**Feasibility Study Monitoring Well Installation Plan  
for RVAAP-66 Facility-wide Groundwater**

**Former Ravenna Army Ammunition Plant  
Portage and Trumbull Counties, Ohio**

Appendix A.	Ohio EPA Comments
-------------	-------------------

**Subject: Response to Ohio EPA Comments on the "Draft RVAAP-66 Facility-wide Groundwater, Feasibility Study Monitoring Well Installation Plan" dated September 20, 2022**

Figure 2-3. RVAAP-10 Load Line 3 Feasibility Study Well Locations

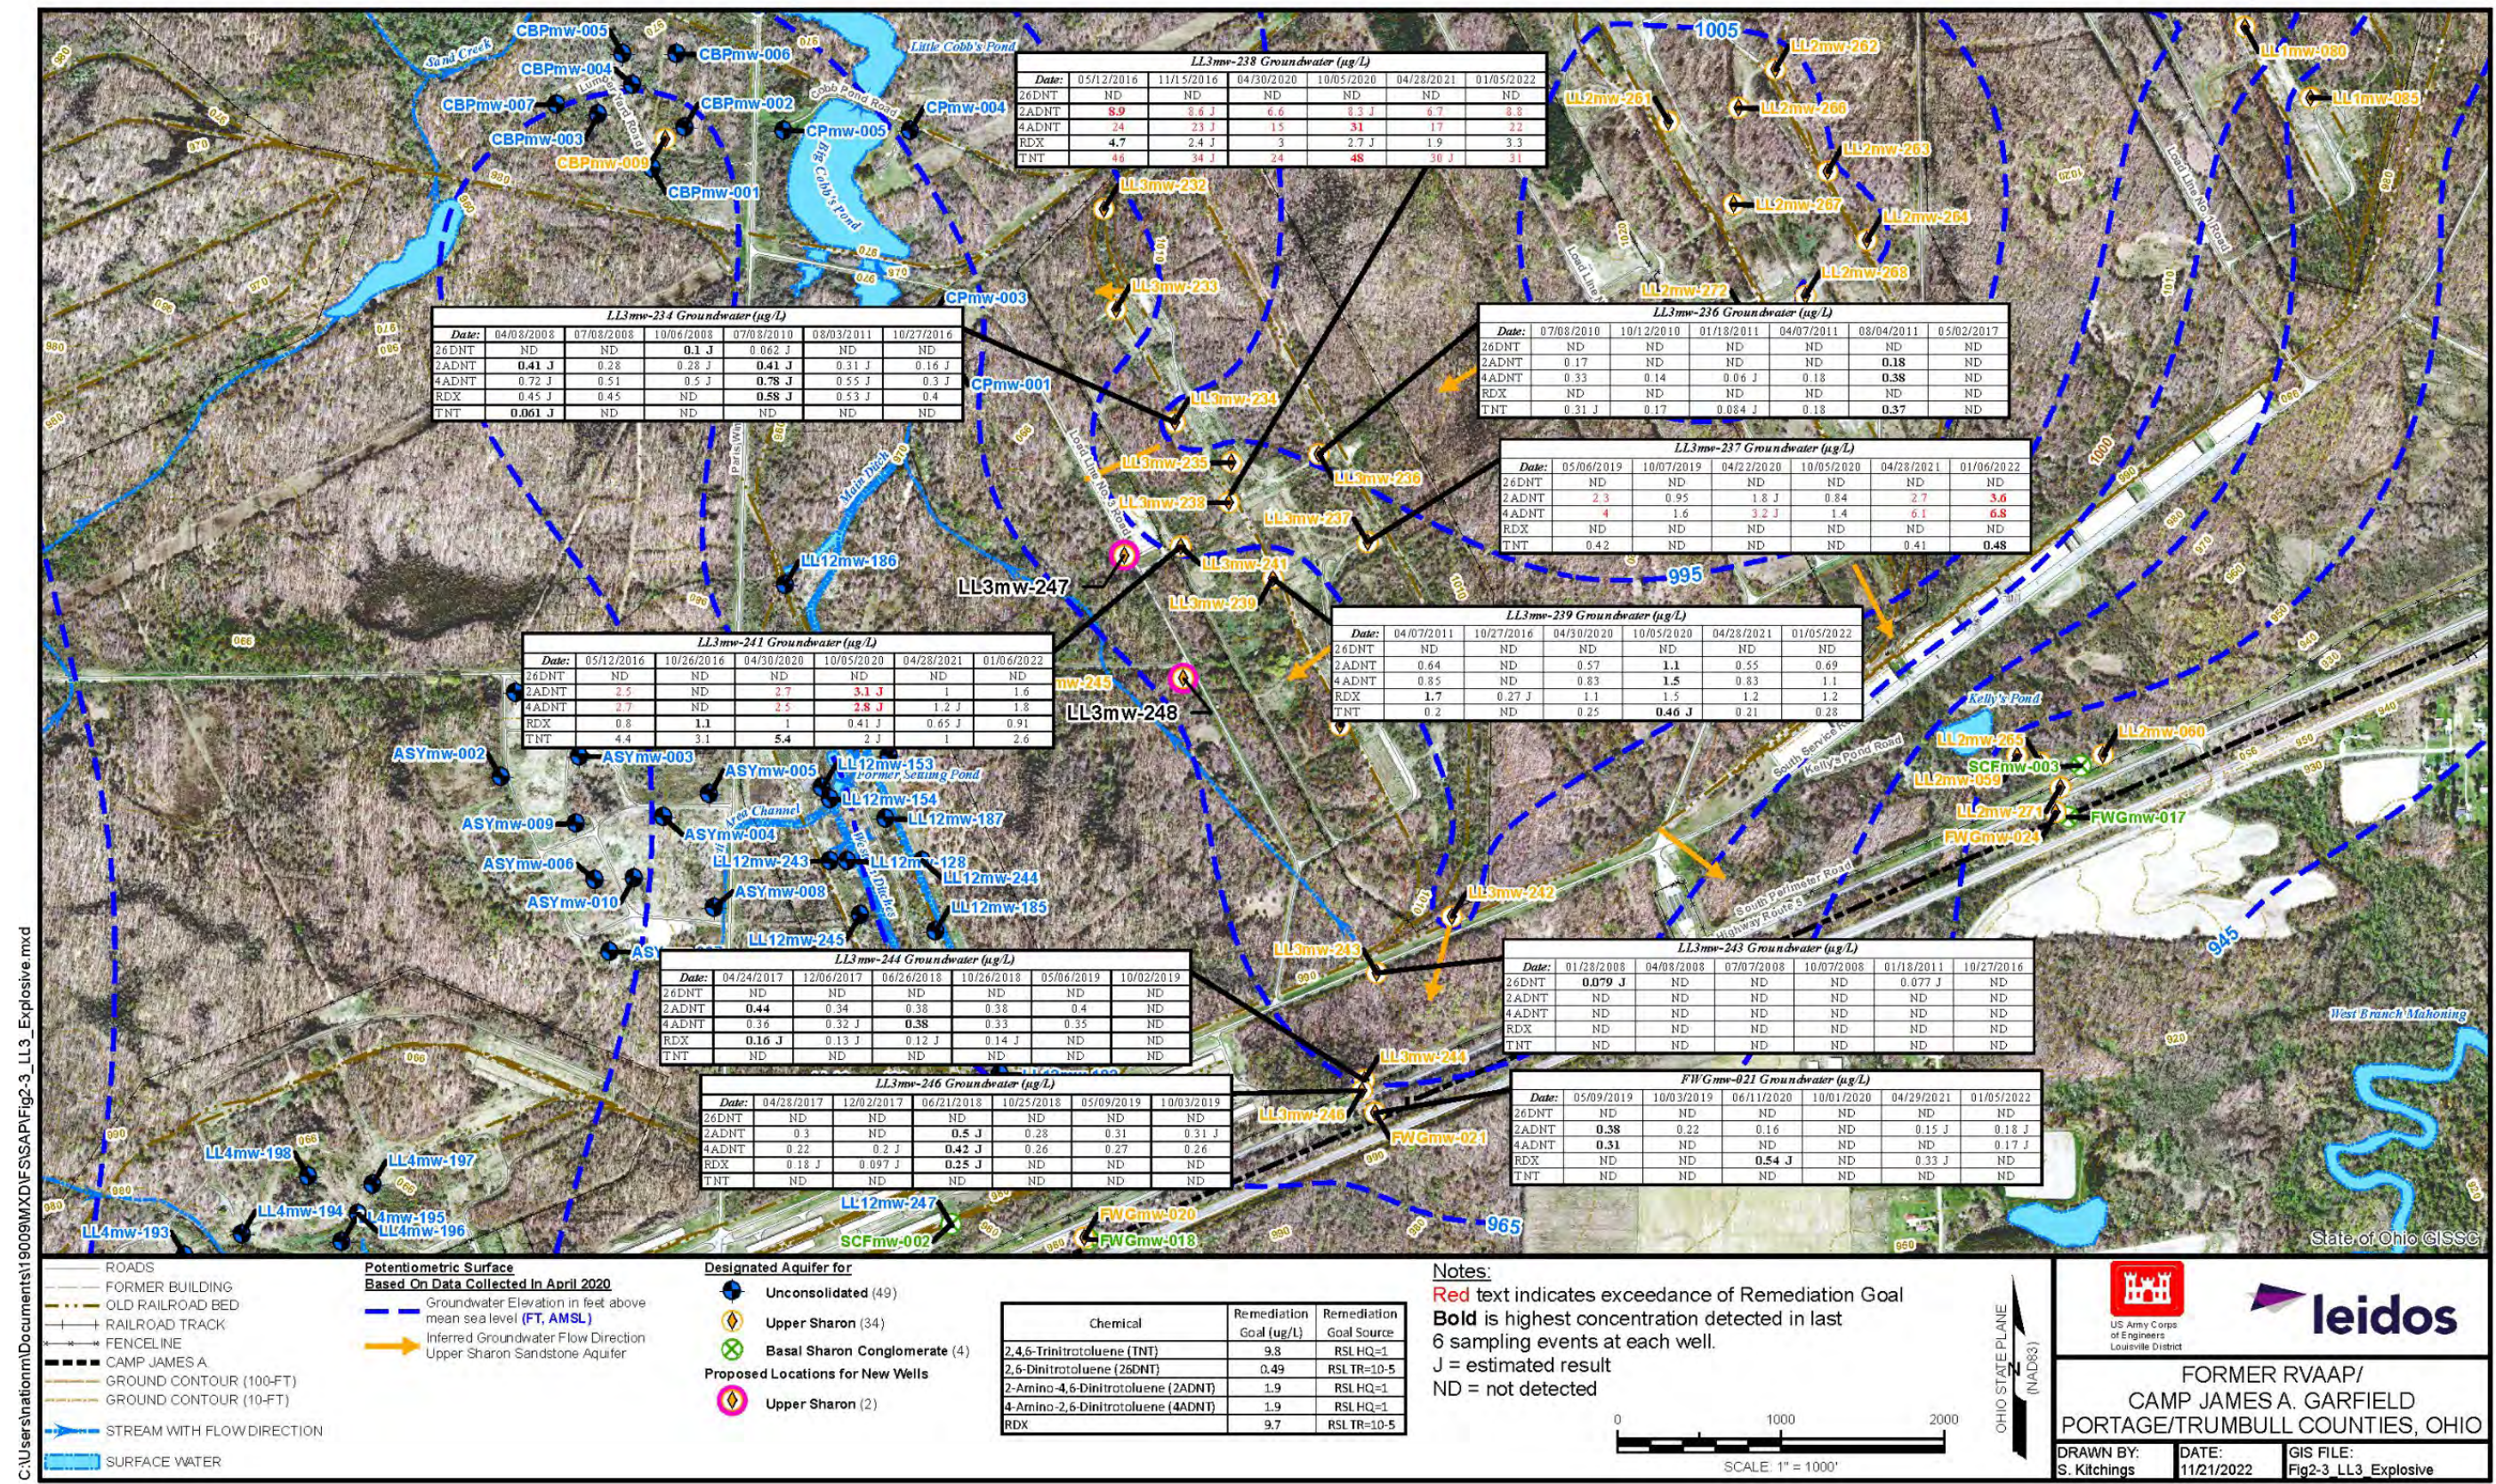
Ohio EPA concurs with the proposed installation of two monitoring wells to be installed west and southwest of Load Line 3 in order to supplement the FS. Further clarification of the proposed locations as denoted on Figure 2-3 of the Draft FS Additional Well Install Plan 2022 is requested, as the current proposed location for LL3mw-247 appears to be over 1,000 feet west of LL3mw-241 and on the opposite side of a stream. To minimize any influence from this surface water feature, to be generally closer to the LL3 source area, and to provide better delineation and better modelling results for the FS, the proposed well location may be better suited further east closer to the Load Line 3 Road. LL3mw-248 could also be located further

north and closer to the LL3 area. Further clarification is requested for the proposed Upper Sharon aquifer screening level to approximately 50 feet bgs. Nearby Upper Sharon wells LL3mw-237, LL3mw-238, LL3mw-239, and LL3mw-241 range from 20 to 35 feet in depth; please clarify why 50 feet depths will be appropriate for Upper Sharon wells.

Ohio EPA concurs with the proposed installation of two monitoring wells to be installed west and south-west of Load Line 3 in order to supplement the FS. Further clarification of the proposed locations as denoted on Figure 2-3 of the Draft FS Additional Well Install Plan 2022 is requested, as the current proposed location for LL3mw-247 appears to be over 1,000 feet west of LL3mw-241 and on the opposite side of a stream. To minimize any influence from this surface water feature, to be generally closer to the LL3 source area, and to provide better delineation and better modelling results for the FS, the proposed well location may be better suited further east closer to the Load Line 3 Road. LL3mw-248 could also be located further north and closer to the LL3 area. Further clarification is requested for the proposed Upper Sharon aquifer screening level to approximately 50 feet bgs. Nearby Upper Sharon wells LL3mw-237, LL3mw-238, LL3mw-239, and LL3mw-241 range from 20 to 35 feet in depth; please clarify why 50 feet depths will be appropriate for Upper Sharon wells.

Army Response: Agree. LL3-247 will be relocated closer to Load Line 3 and east of the surface water feature/stream. LL3-248 is suggested to remain as placed on Figure 2-3. There are slight variations in water levels seasonally, indicating groundwater flow from LL3mw-237 may flow slightly south in the direction of the proposed well location. Furthermore adequate coverage of the westerly flow direction and potential transport or attenuation is captured from data at mw-239 and mw-241. Actual depth to bedrock and well screen interval will be field determined but may occur at any depth between 980-955 ft amsl, therefore the new Upper Sharon wells will be screened within the shallow water bearing zone of the bedrock aquifer. Table 2-1 will be revised to reflect a more likely depth of 25 feet bgs. The text in Section 2.3 will be revised as follows:

Figure 2-4. RVAAP-12 Load Line 12 Feasibility Study Well Locations

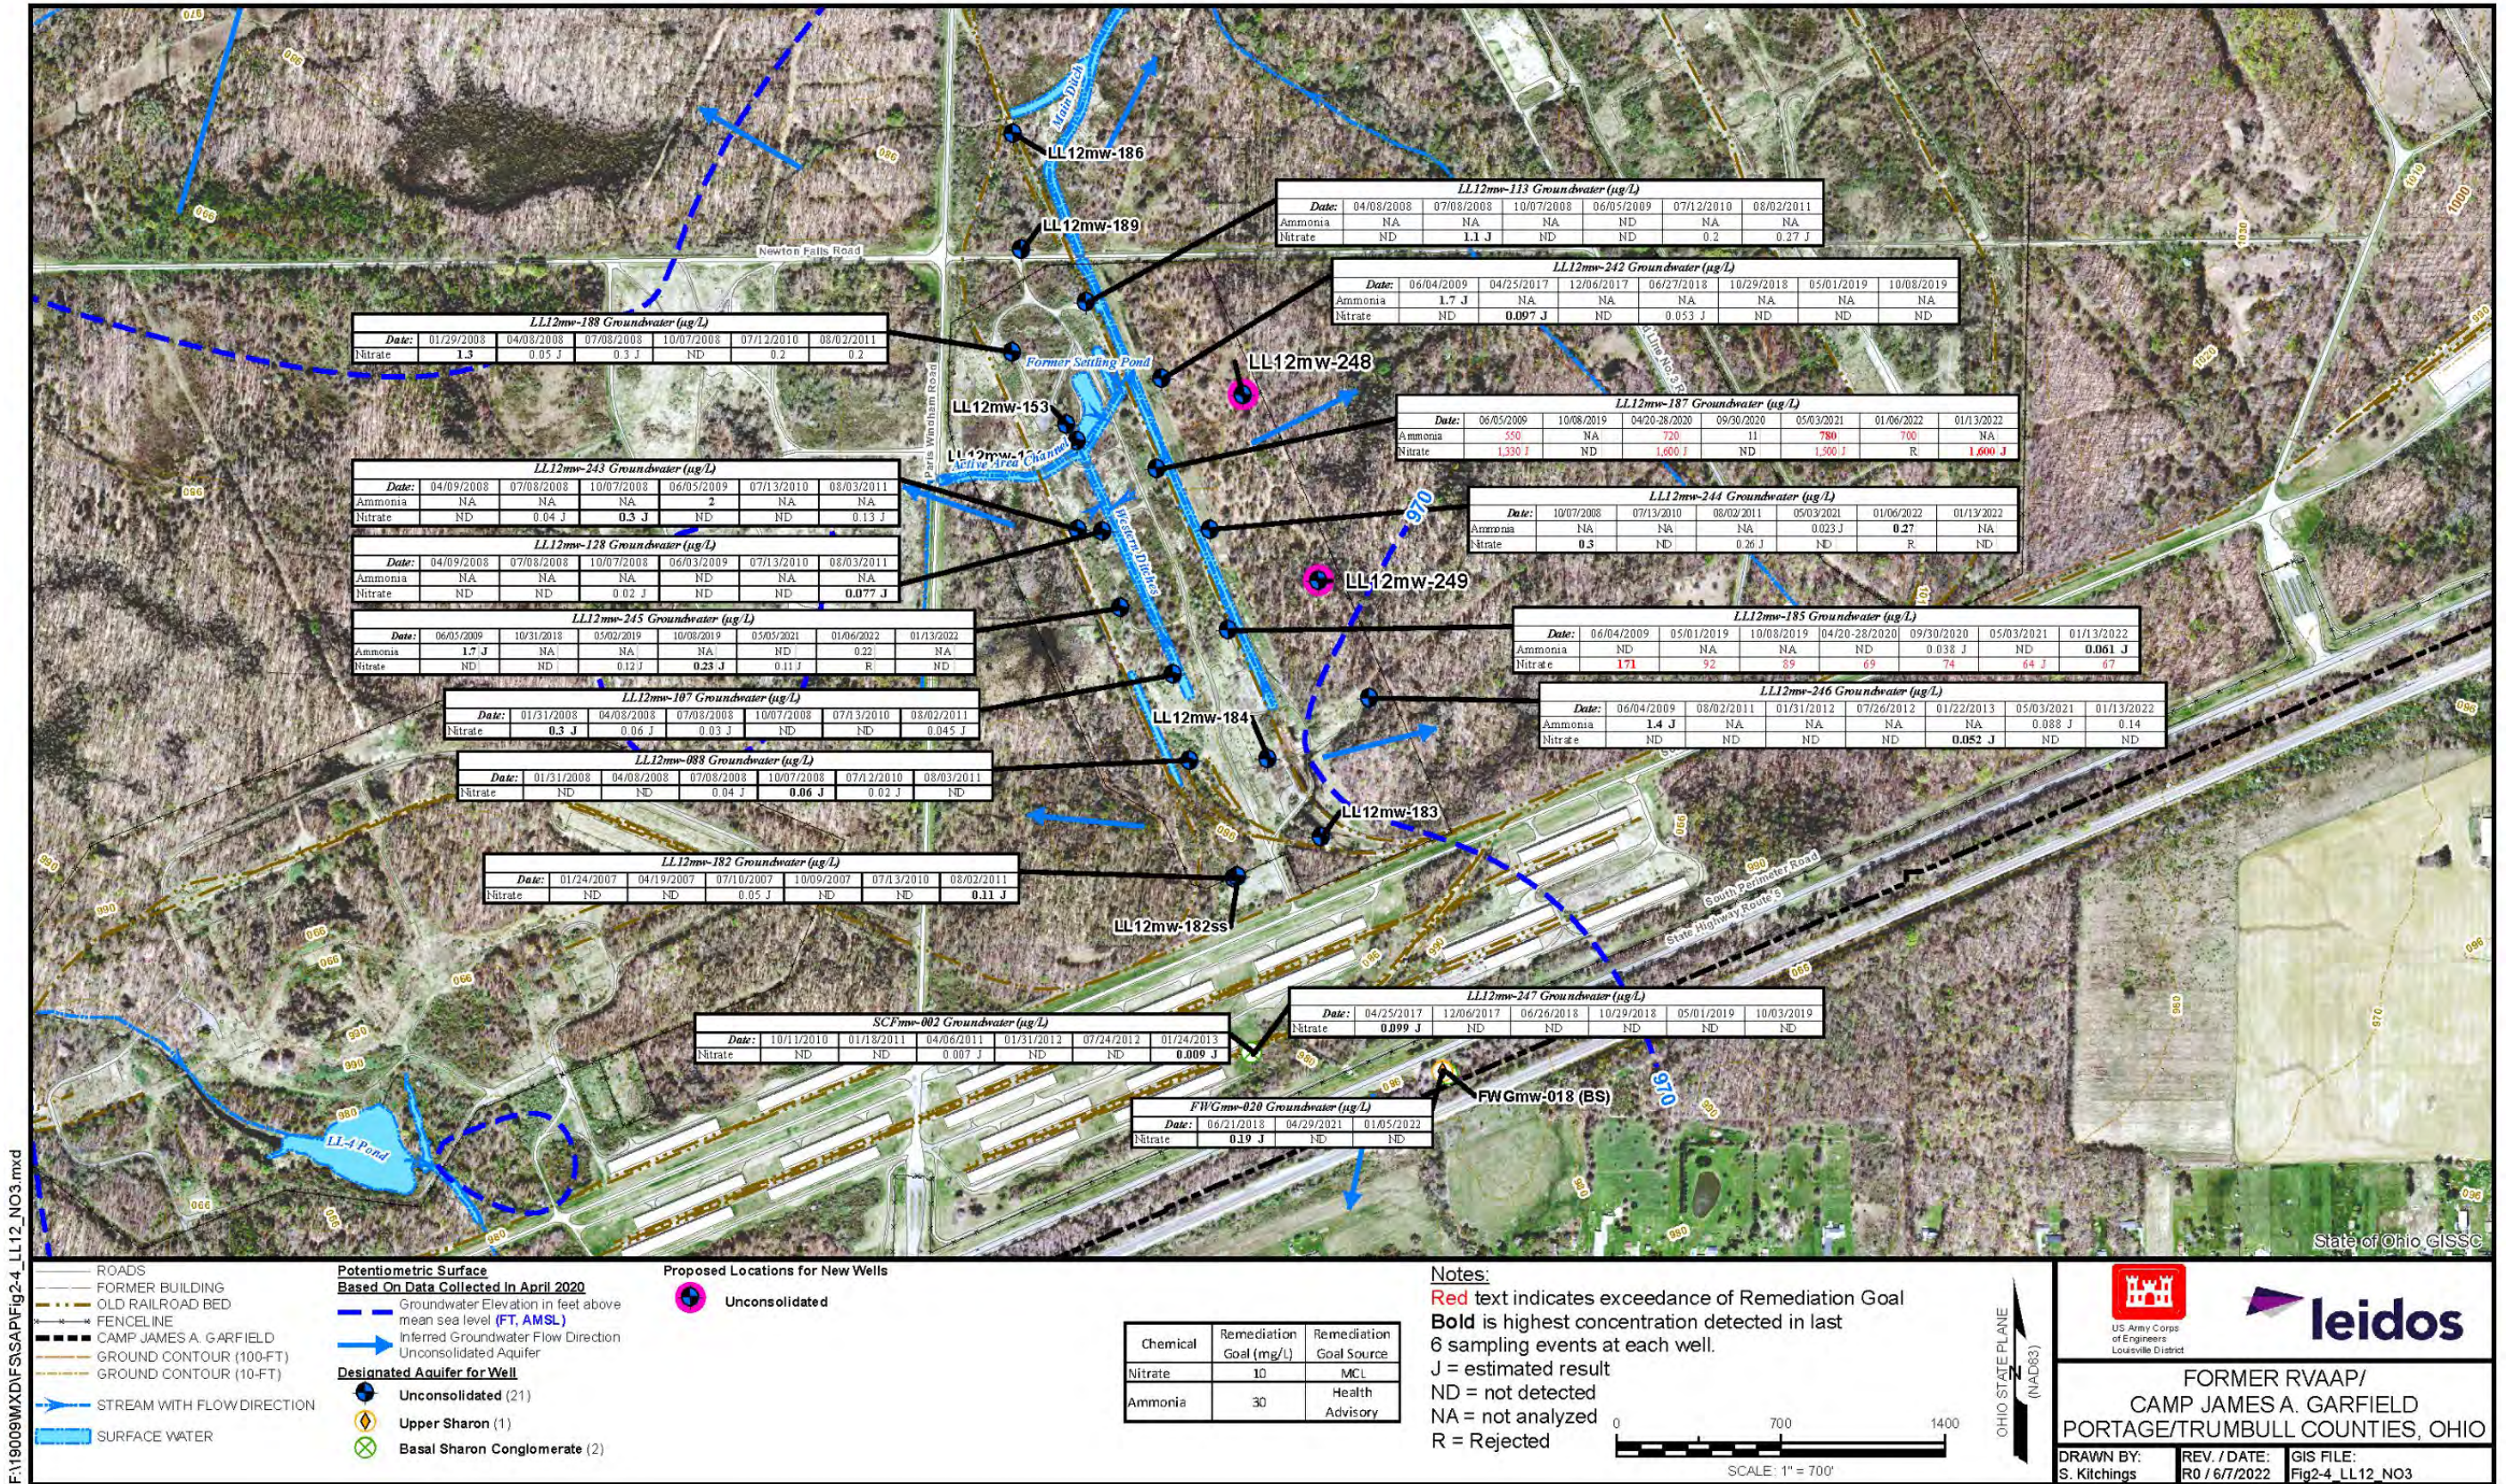
Ohio EPA concurs with the proposed installation of two monitoring wells to be installed east of Load Line 12 in order to supplement the FS and concurs with the proposed locations as denoted on Figure 2-4 of the Draft FS Additional Well Install Plan 2022. The proposed 25 feet depth bgs for the Unconsolidated aquifer wells appears acceptable, with other nearby wells in the LL12 area installed between 24 and 32 feet bgs.

Ohio EPA concurs with the proposed installation of two monitoring wells to be installed east of Load Line 12 in order to supplement the FS and concurs with the proposed locations as denoted on Figure 2-4 of the Draft FS Additional Well Install Plan 2022. The proposed 25 feet depth bgs for the Unconsolidated aquifer wells appears acceptable, with other nearby wells in the LL12 area installed between 24 and 32 feet bgs.

Army Response: Comment noted.
